ENSTROM HELICOPTER CORPORATION

SERVICE DIRECTIVE BULLETIN NO. 0064

SUBJECT: Collective Friction Usage

MODELS: F-28A, 280, F-28C, 280C, F-28F and 280F

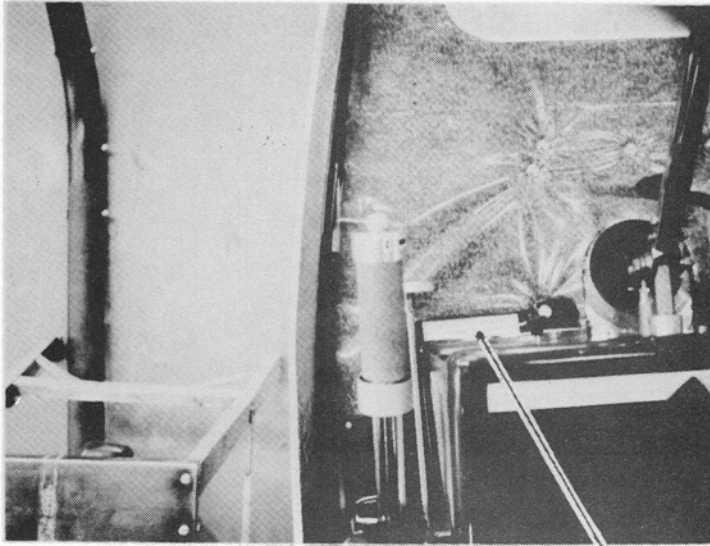
Current production Enstrom helicopters are placarded "COLLECTIVE FRICTION TO BE USED FOR GROUND OPERATION ONLY" on the fiberglass seat flair near the collective friction handle (refer to picture). Included with this bulletin is the placard which must be installed, as shown, on all Enstrom helicopters. Additional decals can be obtained from Enstrom Helicopter Service Department by ordering P/N 28-16296-11.

NOTE: Placard to be positioned even with edge of seat cover and inverted to facilitate reading by pilot.
